AS9759 REV. A

AEROSPACE STANDARD

BOLT, MACHINE - DOUBLE HEXAGON EXTENDED
WASHER HEAD, DRILLED, PD SHANK,
AMS4967 (TI 6AL-4V), .1900-32 UNJF-3A

AS9759
SHEET 1 OF 2

FIGURE 1 - BOLT

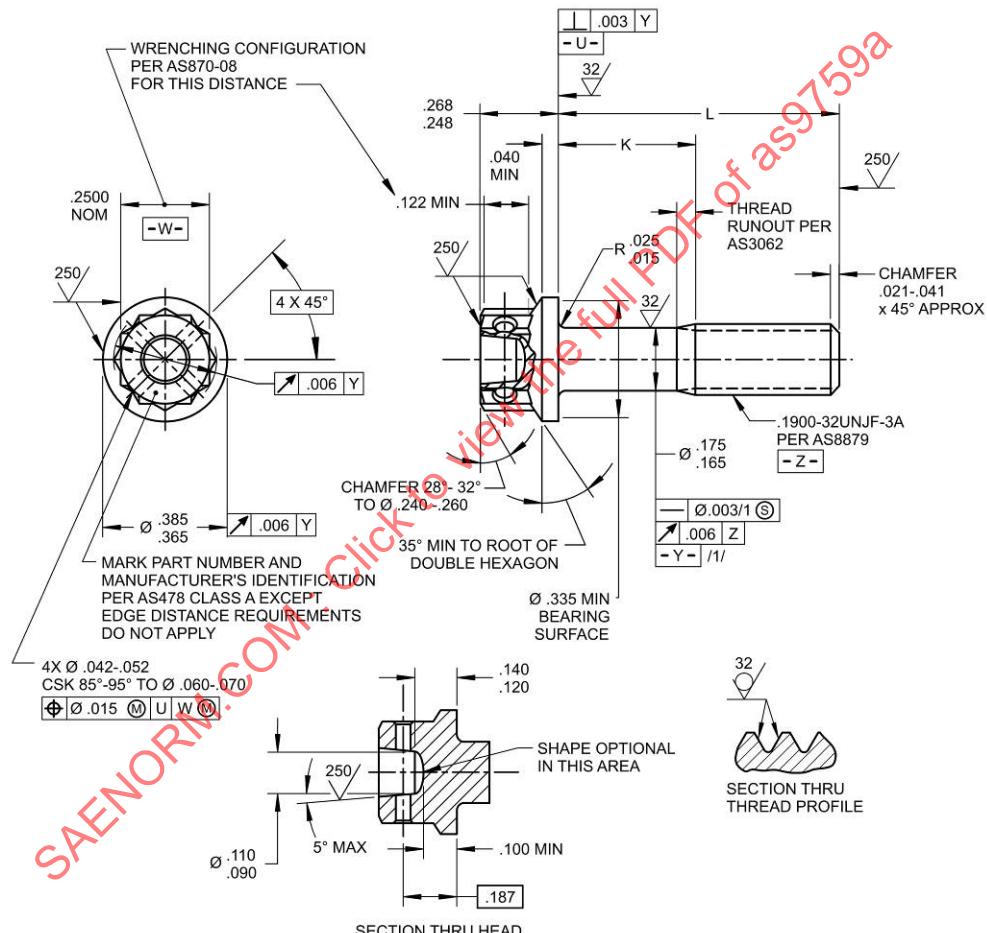
GENERAL REVISION. REVISE LIGHTENING HOLE CONFIGURATION (ADD SECTION VIEW) TO ALLOW OPTIONAL SHAPE AT BOTTOM OF HOLE, ADD EXCEPTION TO EDGE DISTANCE REQUIREMENTS FOR HEAD MARKING, UPDATE THREAD SPECIFICATION TO AS8879, UPDATE SURFACE FINISH REQUIREMENTS, ADD AS3062 AND DELETE NOTE ON FILLET FOR INCOMPLETE THREAD REQUIREMENTS, ADD DATUM REQUIREMENTS FOR -03 THRU -14 LENGTHS (NEW NOTE 1), UPDATE DIMENSIONING AND TOLERANCING TO ANSI Y14.5M-1982, DELETE .015 MAX RADIUS AT BASE OF WRENCH PAD, DELETE HARDNESS NOTE, AND FIGURE 1 REDRAWN.
